VVTA RFP 2021-07 SECURITY CAMERA SYSTEM UPDATE ADDENDUM NO. 3

Friday, February 12, 2021

This addendum is provided to all known prospective proposers for clarification of the subject Request for Proposal (RFP).

VTA Administration Building First Floor

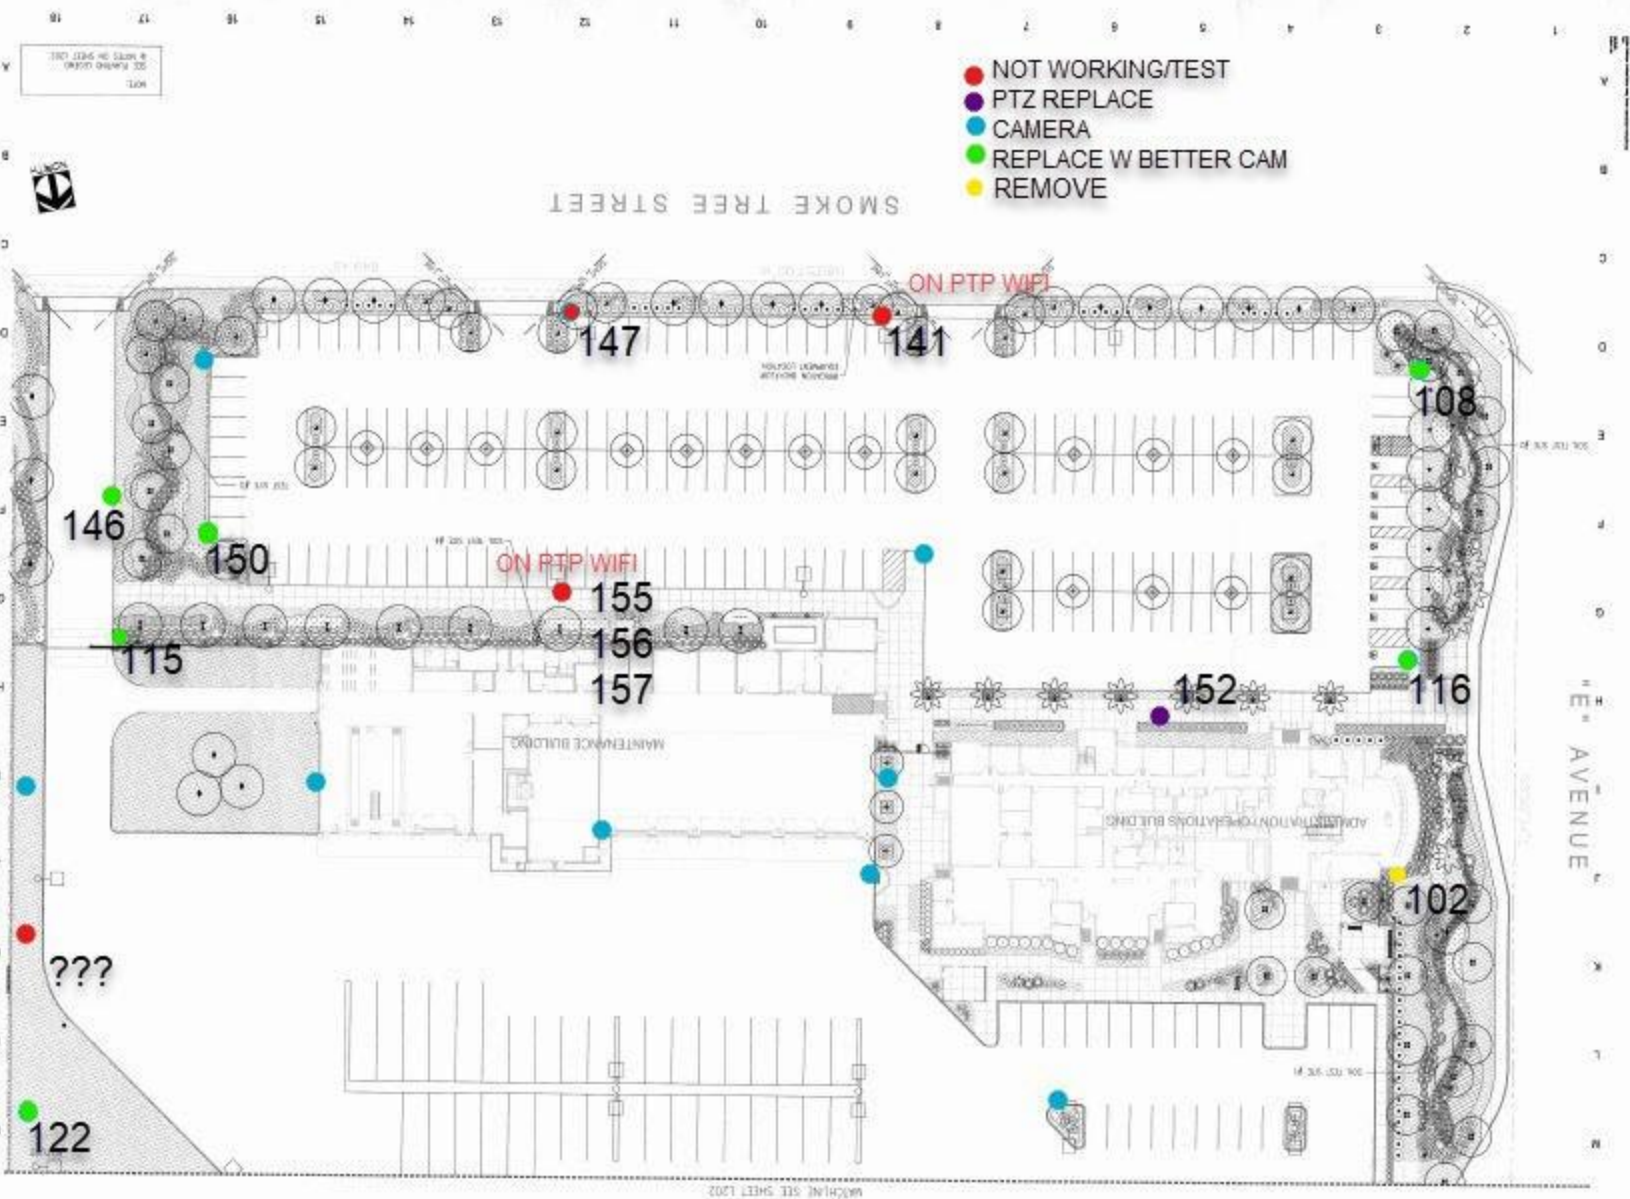
We would like more visibility of the highlighted area

- REPLACE W/BETTER CAM
- ADD PTZ
- CAMERA
- ADD CAMERA WITH AUDIO
- REMOVE

- NOT WORKING/TEST
- PTZ REPLACE
- CAMERA
- REPLACE W BETTER CAM
- REMOVE

WTA CNG/Bus Wash Building

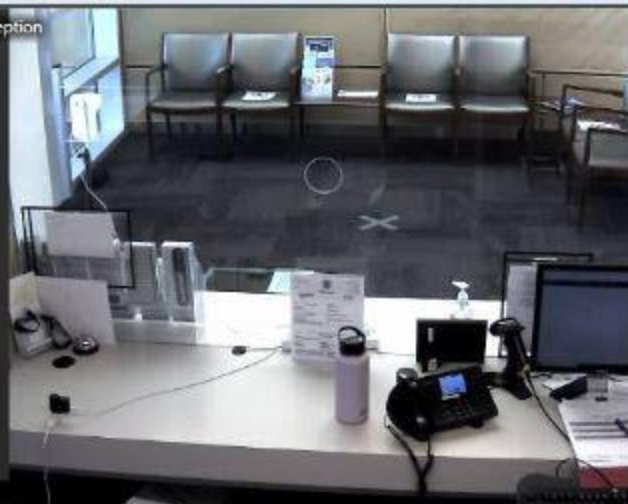
- REMOVE
- CAMERA W/AUDIO
- CAM WIDER VIEW
- CAMERA

1 112-Money Room South

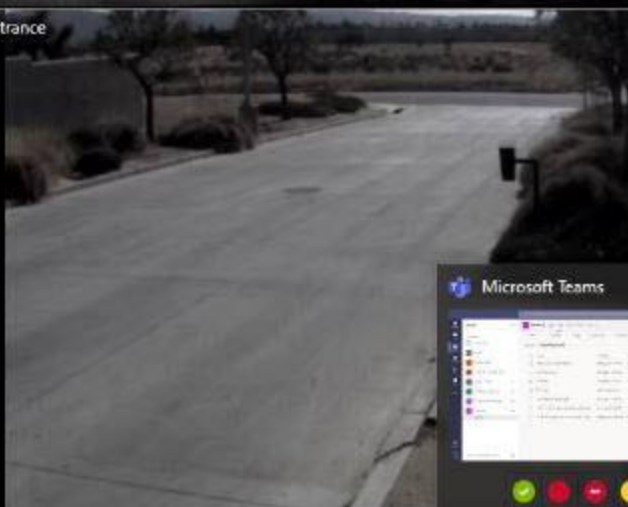
101-Troubleshoot/Replace if needed

104-Replace with better camera w/audio

108-Replace with better Camera/wider angle

110-Replace with better camera/Wider angle

112-Replace with better camera w/audio
114-Replace with better camera/ wider angle
115-Replace with better camera/IR
116-Replace with better camera

1 122-N.E. Corner on wall by Shed

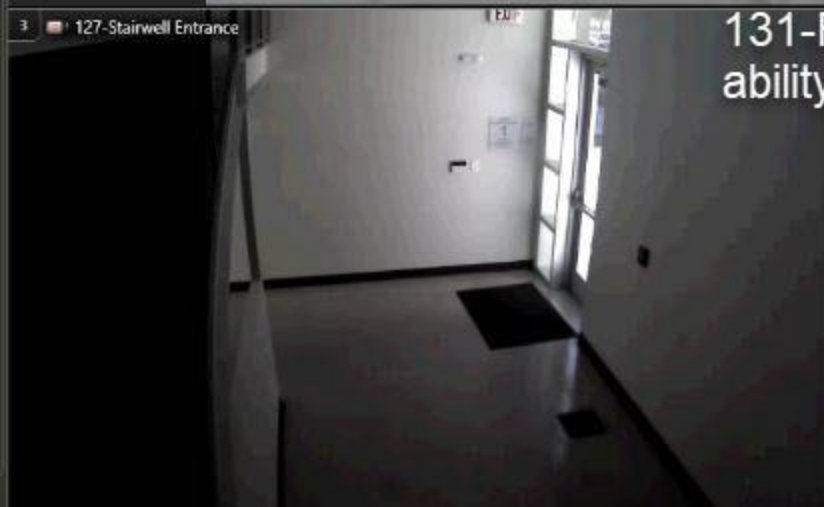
122-Replace with better camera
123-Change the angle

127-Replace with better camera

131-Replace with better camera,
ability to view license plates

1 136-ADA Dispatch

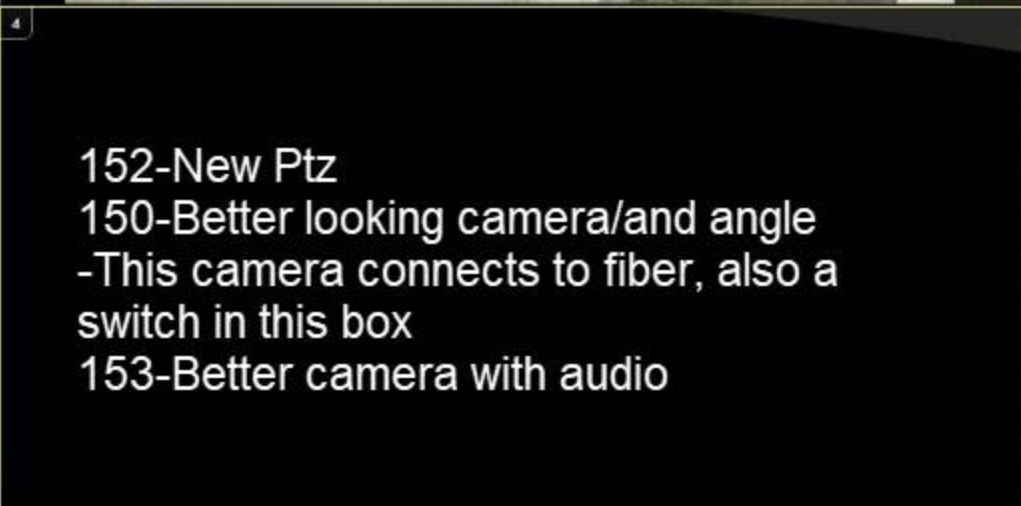
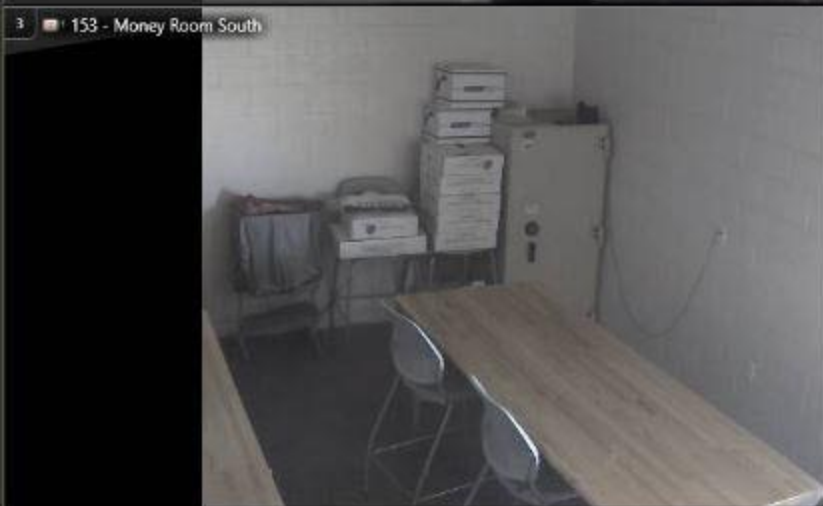
136-Replace with Camera w/audio
139-Replace with Camera w/audio
146-Replace Better Camera IR

1 155 - Server Camera - 02

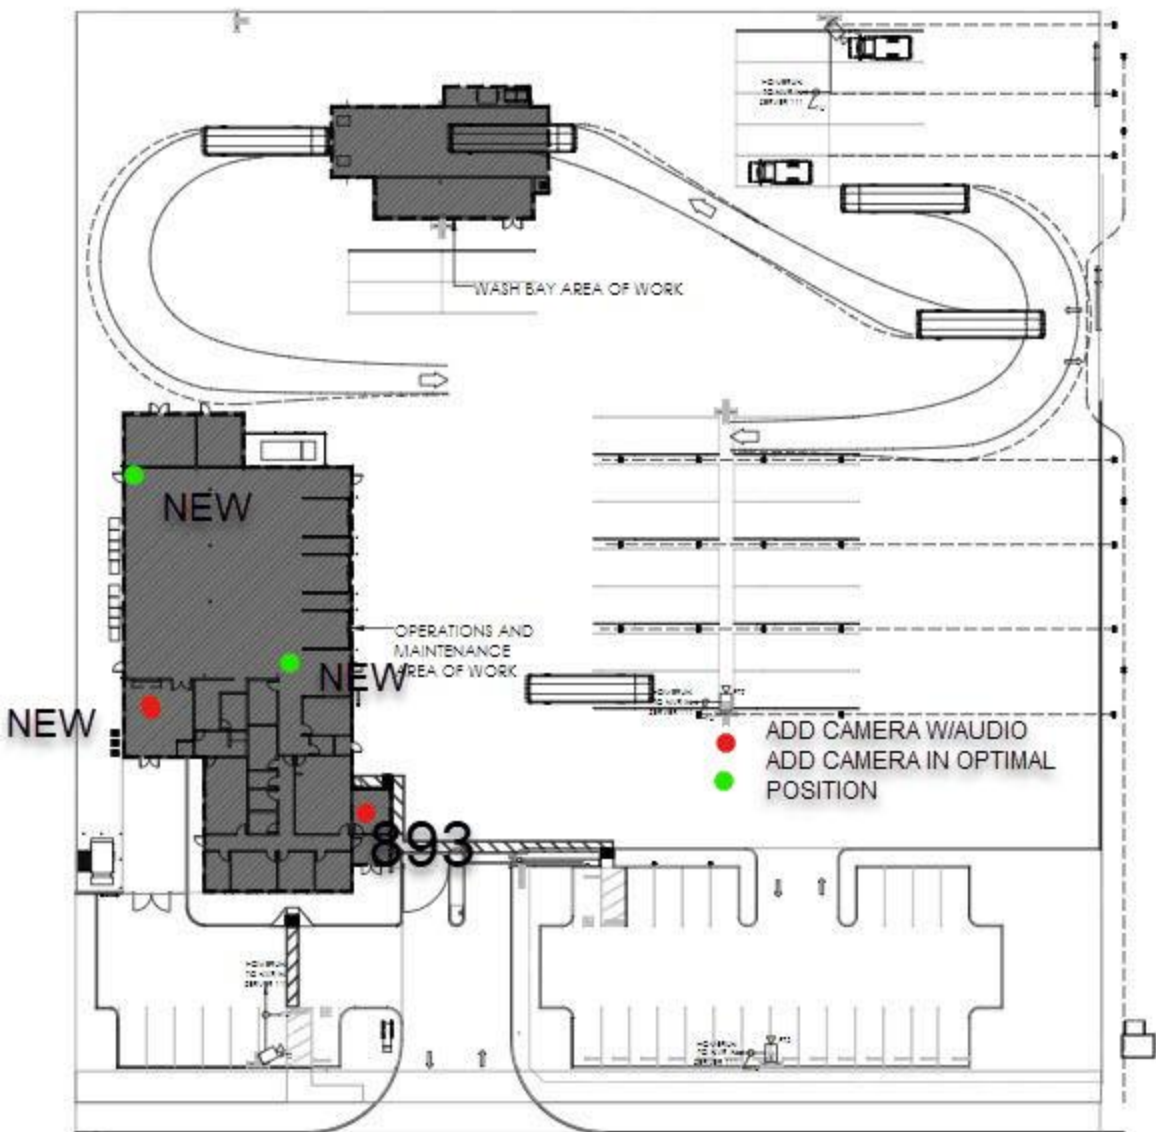
Please trouble shoot
This is a New Camera
These cameras connect to ptp wifi
Fix angle on view

EXHIBIT 3

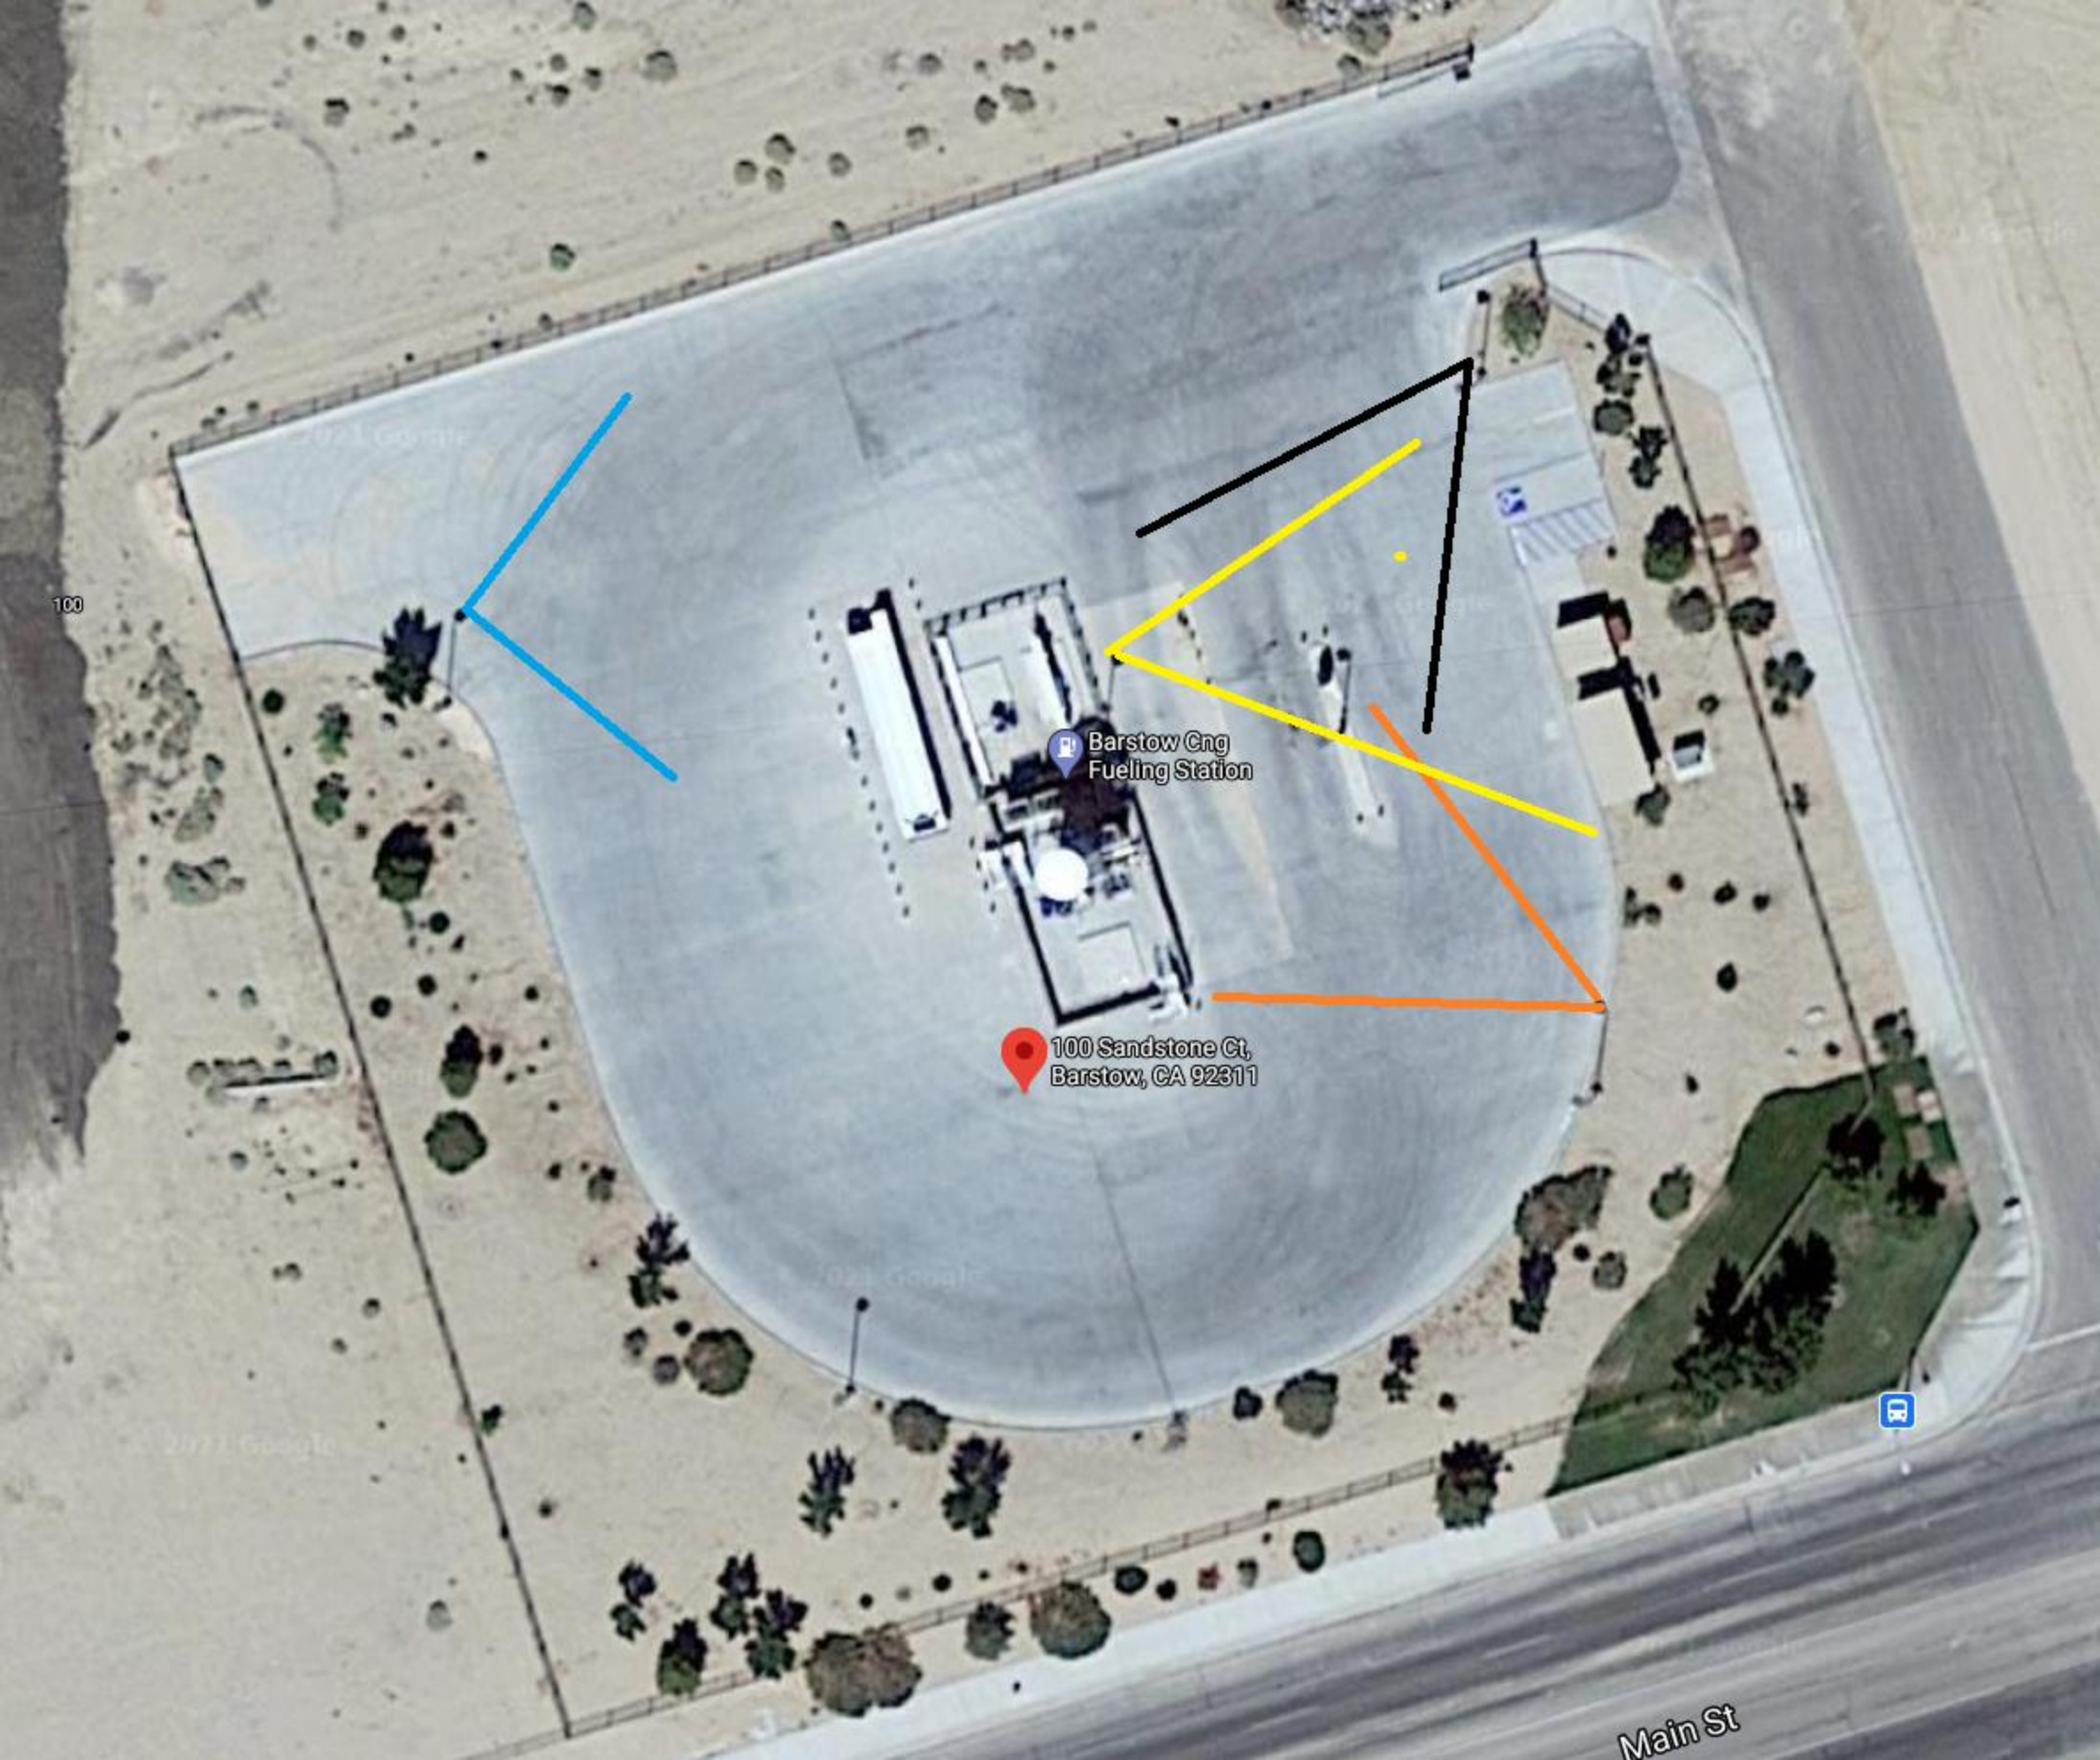
Please see the attached site map and camera listing. The new 4 cameras are marked on the attached plan.
